UNITED STATES PATENT AND TRADEMARK OFFICE

APPLICATION NO.	FILING DATE	FIRST NAMED INVENTOR	ATTORNEY DOCKET NO.	CONFIRMATION NO.
10/608,987	06/26/2003	John R. Hawkins	DEP5118	6430

Office Action Summary	Application No.	Applicant(s)	
	10/608,987	HAWKINS, JOHN R.	
	Examiner	Art Unit	
	Anu Ramana	3732

DETAILED ACTION***Continued Examination Under 37 CFR 1.114***

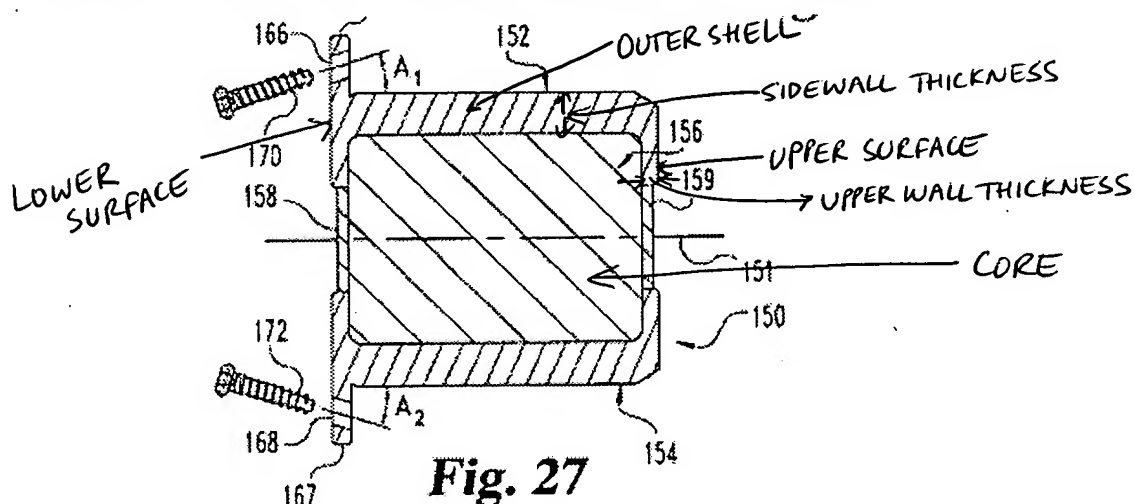
Zdeblick et al. disclose a disc implant having an outer shell 152 surrounding an elastic core 156 wherein a lower surface of the implant has a recess and a screw or "pin" 170 received in the recess (Figs. 25 and 27, col. 4, lines 65-67, col. 5, lines 1-14 and col. 9, lines 32-63). Also see marked up Fig. 27 below.

Regarding claims 6 and 29, the thickness of the sidewall of the implant of the combination of Zdeblick et al. and Lawson et al. approximates a thickness of the annulus fibrosus. See marked up Fig. 27 on previous page.
